Docket Item #8
Development Special Use Permit #2011-0003 – James Bland
(Amendment to DSUP #2008-0013)

Application	General Data	
Project Name: James Bland	PC Hearing:	March 1, 2011
	CC Hearing:	March 8, 2011
	If approved, DSUP Expiration:	March 8, 2014 (3 years)
Location: 898 North Alfred St.	Zone:	CDD #16
	Proposed Use:	Townhouse and Multifamily
Applicant: EYA and ARHA	Small Area Plan:	Braddock Road Metro and Braddock East Plans
	Historic District:	Parker-Gray
	Green Building:	Will conform to requirements in DSUP 2008-0013

Purpose of Application
A consideration of requests to amend Development Special Use Permit #2008-0013 (James Bland) to construct three multifamily buildings instead of two multifamily buildings on Block 898 and to revise the architectural design of these buildings. In addition, consideration of a change to the phasing plan for the project to allow Block 898 to be the third phase of the project.
Staff Recommendation: APPROVAL WITH CONDITIONS
Staff Reviewer(s): Dirk H. Geratz, AICP; dirk.geratz@alexandriava.gov Katye Parker, AICP, LEED AP; katye.parker@alexandriava.gov Maya Contreras; maya.contreras@alexandriava.gov

DSUP #2011-0003 3/1/2011

Attachment #2 – Open Space Expansion

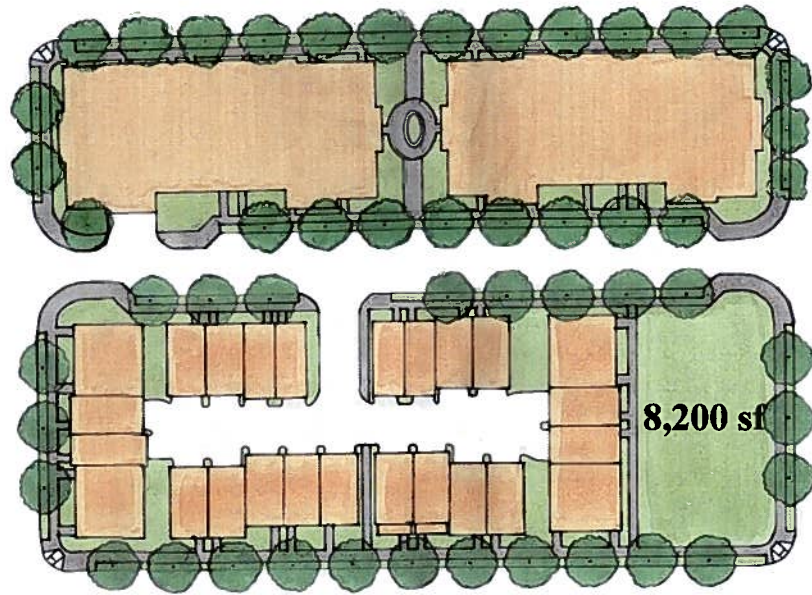
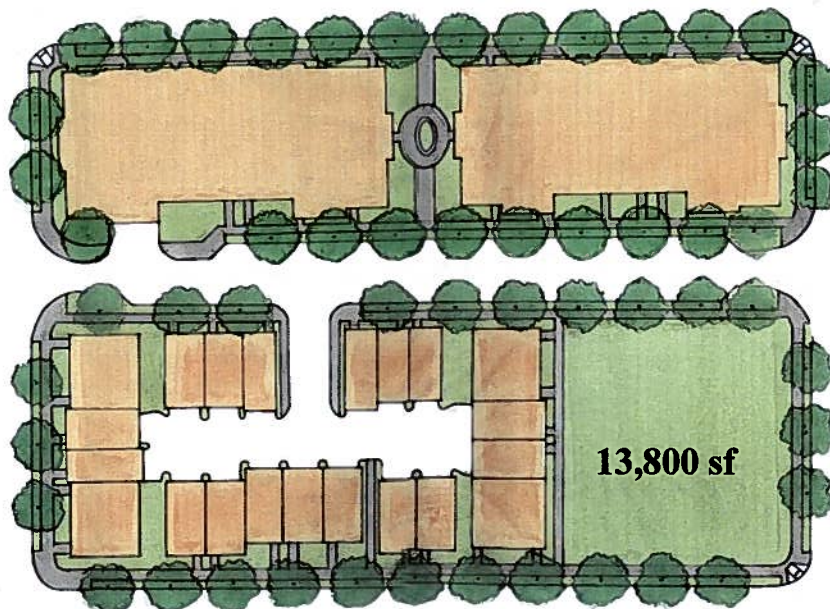
9. **[CONDITION AMENDED]** The applicant shall revise the site plan to eliminate 4 units in the southwestern block to provide a larger open space area at the corner of Montgomery Street and N. Alfred Street as generally depicted in *Attachment #2*. The park shall be subject to the following, to the satisfaction of the Directors of P&Z and RP&CA:

- b. In order to increase the size and viability of the proposed major park at the James Bland Redevelopment site, it is proposed that the City purchase from ARHA four market rate building lots adjacent to the planned open space at the southwest corner of Montgomery and Alfred Streets. This purchase of the four lots will increase the size of the park from about 8,200 square feet to approximately 13,000 square feet.
